Re: Docket No. 49879
Application to Obtain or Amend a Water Certificate of
Convenience and Necessity (CCN)
Swift Water Supply Corporation (CCN # 11420)
in Nacogdoches County;

Please find enclosed one (1) original and seven (7) copies of the requested information (listed or answered below) outlined in the PUC Interoffice Memorandum dated November 21, 2019 for the above referenced Docket No. 49879 (Swift Water Supply Corporation).

Subject: **Docket 49879**, Application of Swift Water Supply Corporation to Amend its Water Certificate of Convenience and Necessity in Nacogdoches County

SWIFT WSC CCN AMENDMENT AREA A

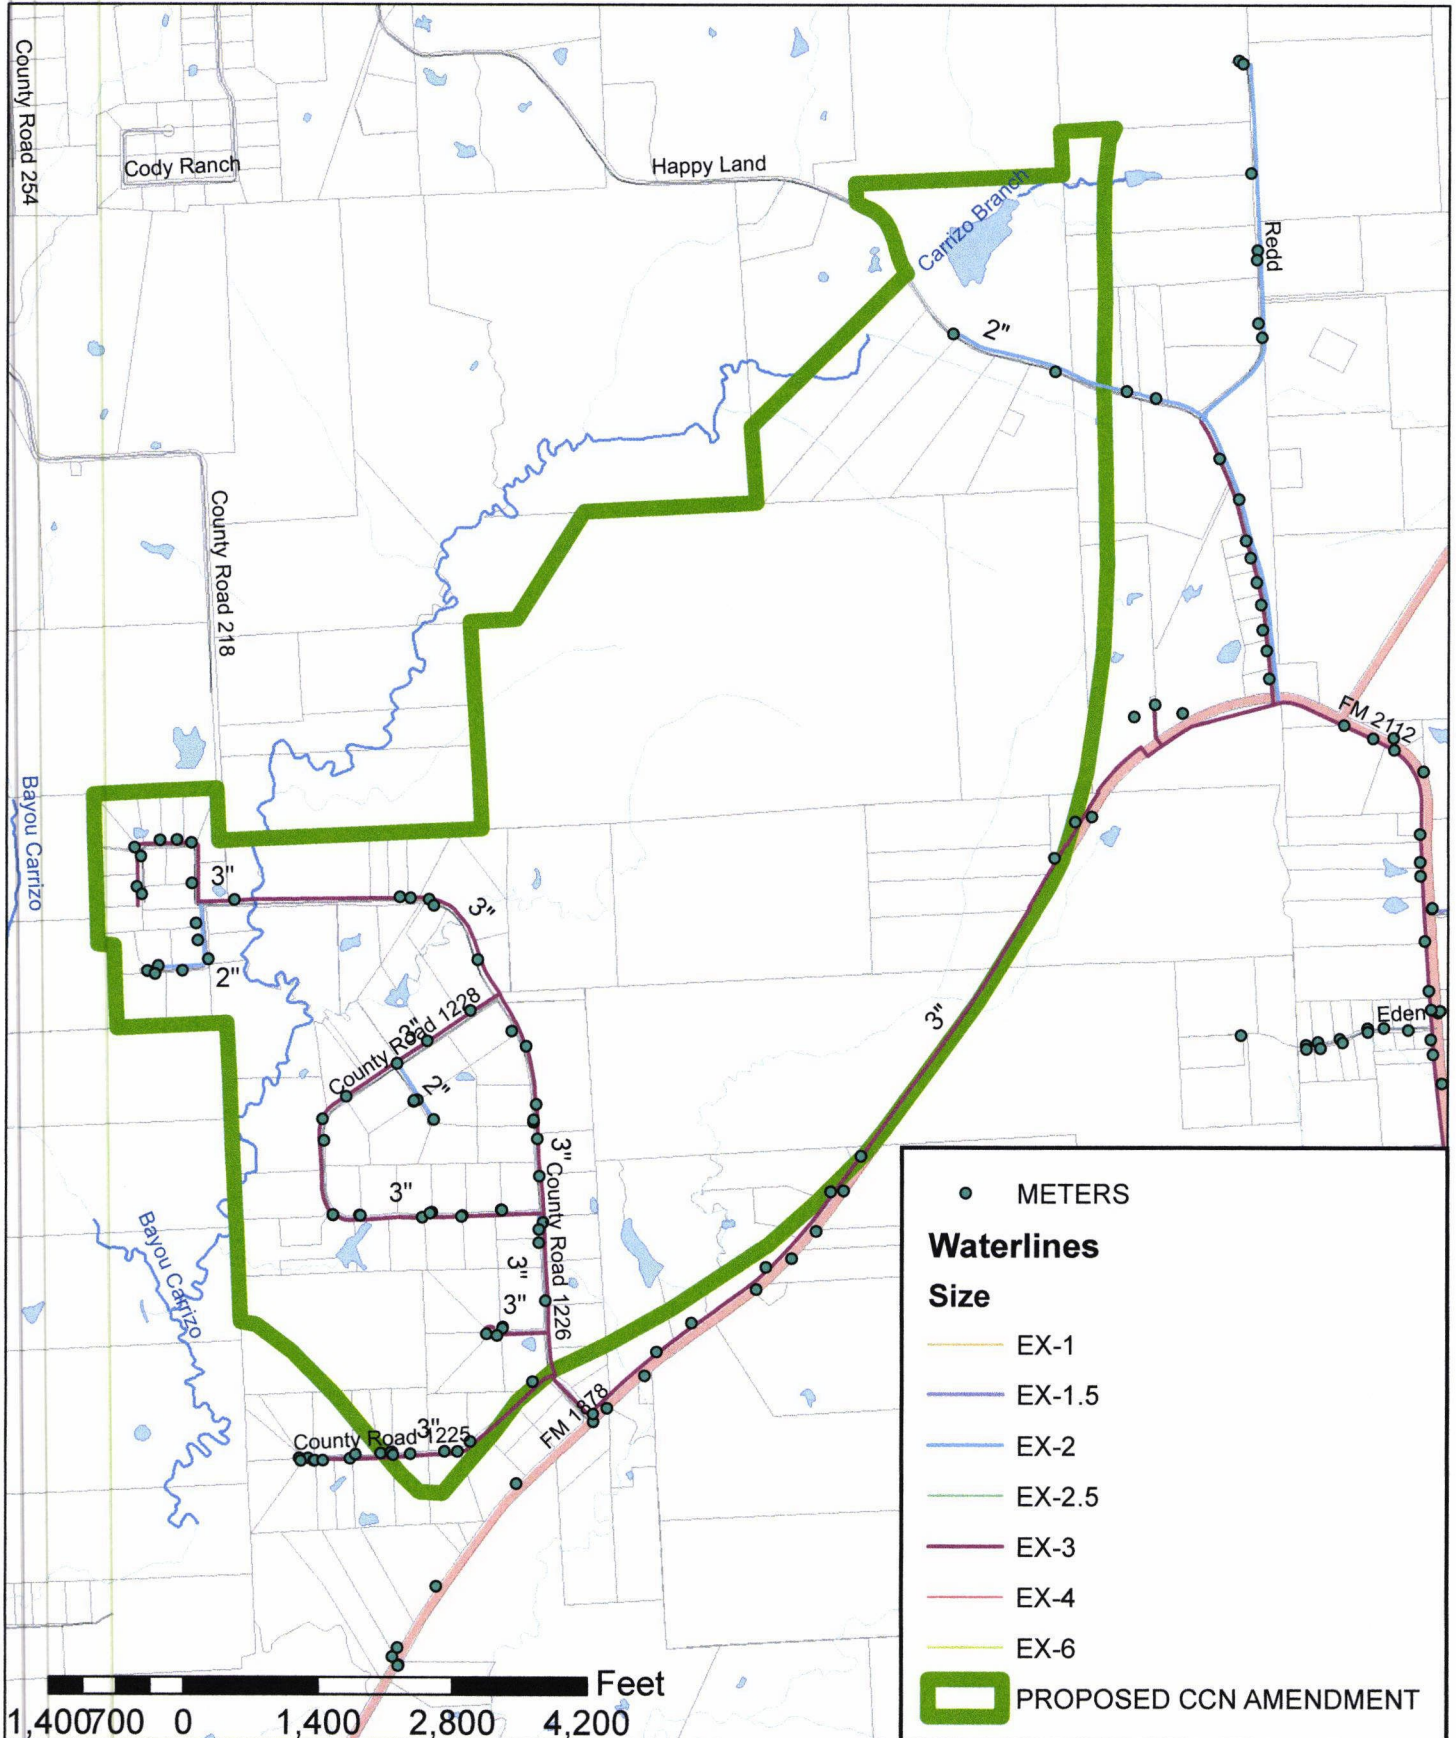
- Provide detailed maps showing existing customers and any potential customers who have requested service within the requested area.
- Provide detailed maps showing existing and proposed water transmission and distribution lines within the requested areas.

The maps you requested are attached (Listed Item No. 1 & 2).
